#### **ADDENDUM 4**

**Subject: BID # 11-045, Construction for the Tornillo Guadalupe New International Bridge**

**TORNILLO-GUADALUPE NEW INTERNATIONAL BRIDGE**

BRIDGE LAYOUT  
SPAN 13

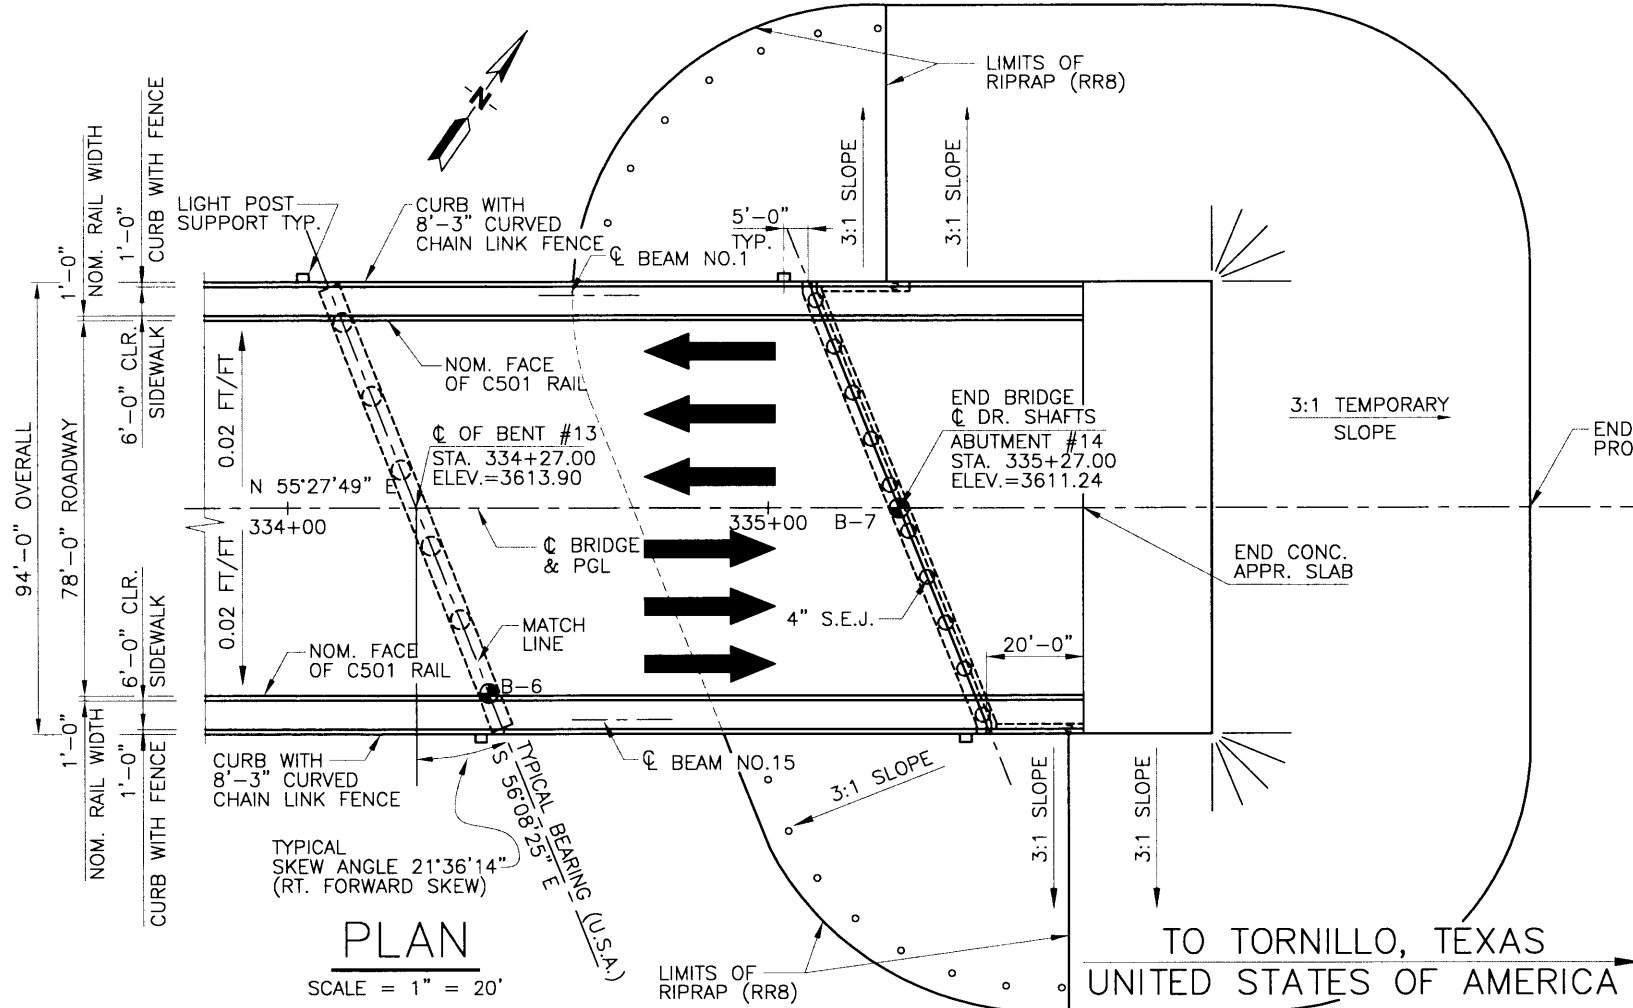
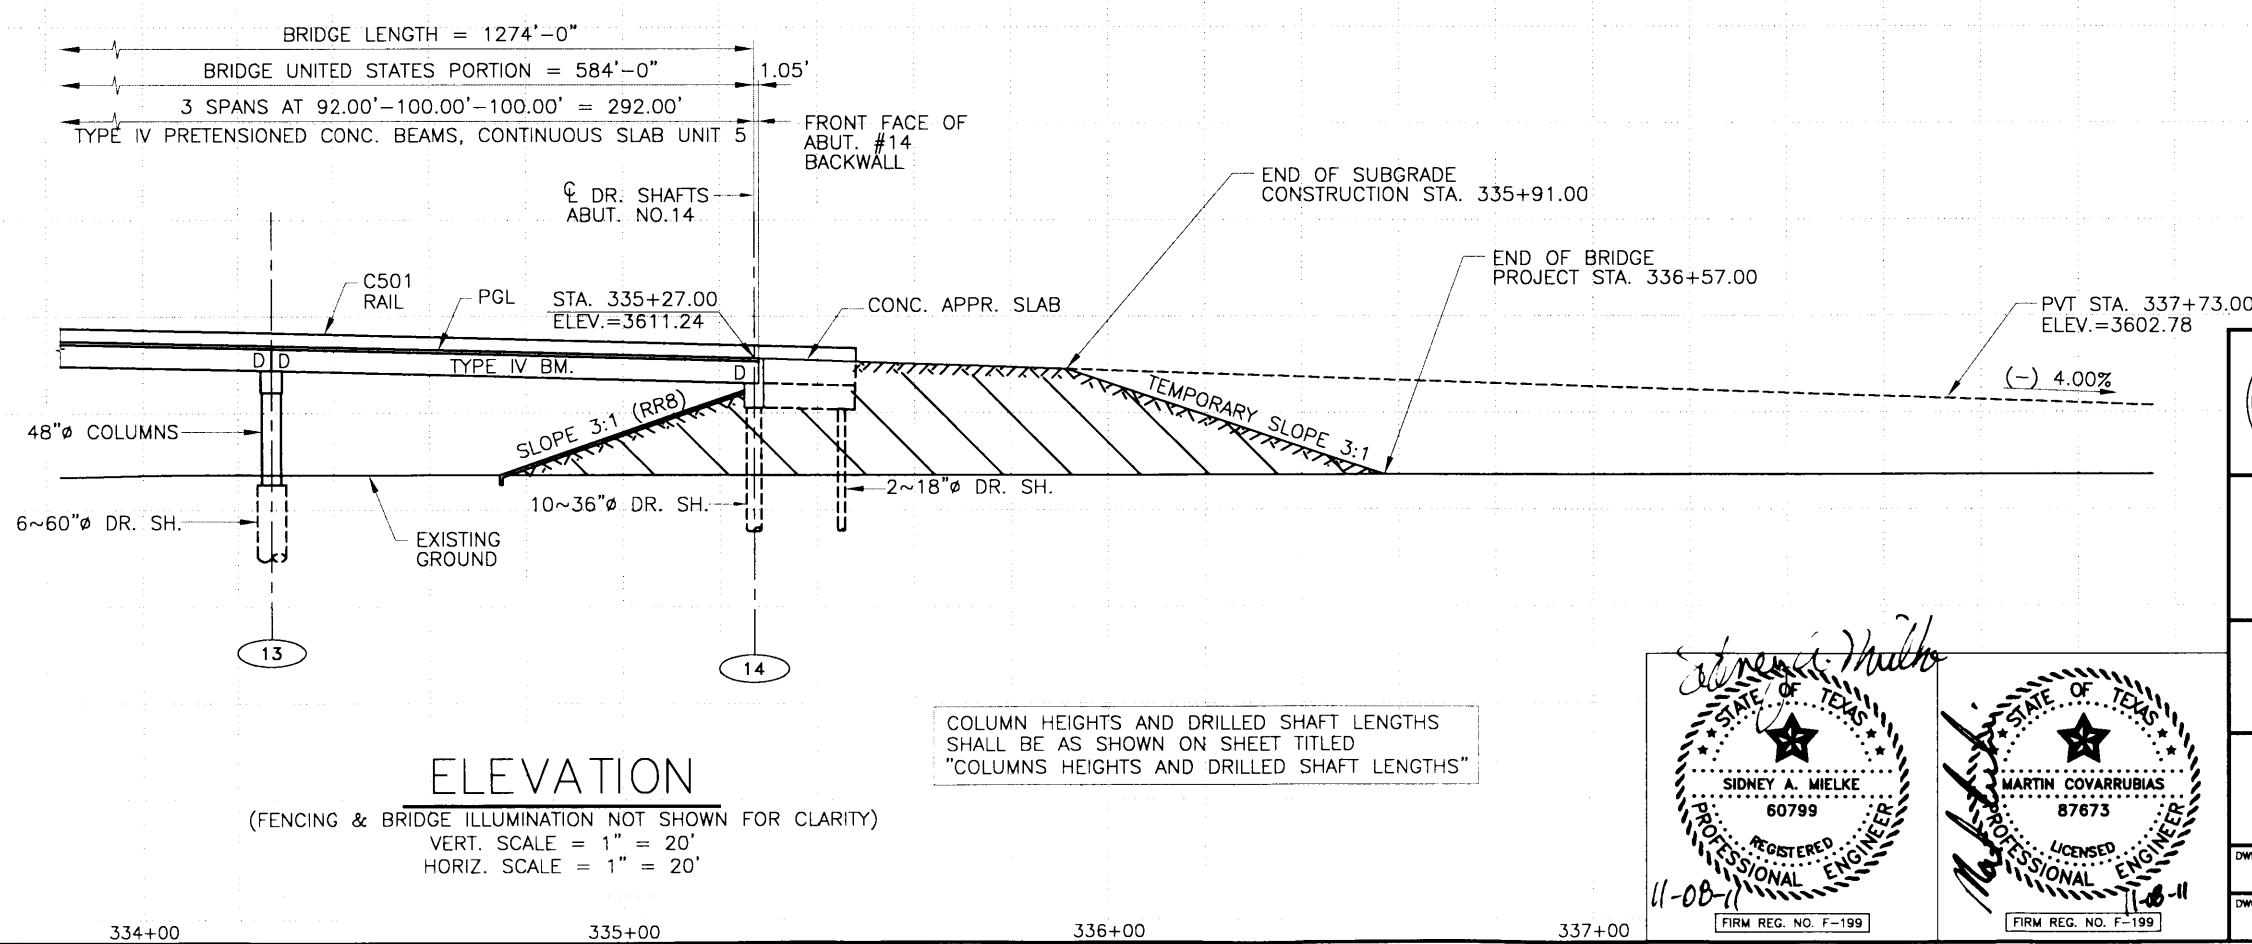
**Q20: The note on sheet 14 says embankment can be obtained from on site sources. Can you clarify?**

A20: An addendum will be issued and the note will be changed to "Material for embankment must be obtained from offsite sources."

**Item # 3 The following supplemental information is provided in response to question # 20 of the pre-bid conference:**

The note on sheet 14 has been revised to read as follows: "Material for embankment must be obtained from offsite sources." See attached revised sheet 14.

NOTE:  
MATERIAL FOR EMBANKMENT MUST BE OBTAINED FROM OFF SITE SOURCES.  
CONTRACTOR TO COMPLETE EMBANKMENT AND ABUTMENT #14 AT EARLIEST POSSIBLE DATE BUT NO LATER THAN 25 MAY 2012
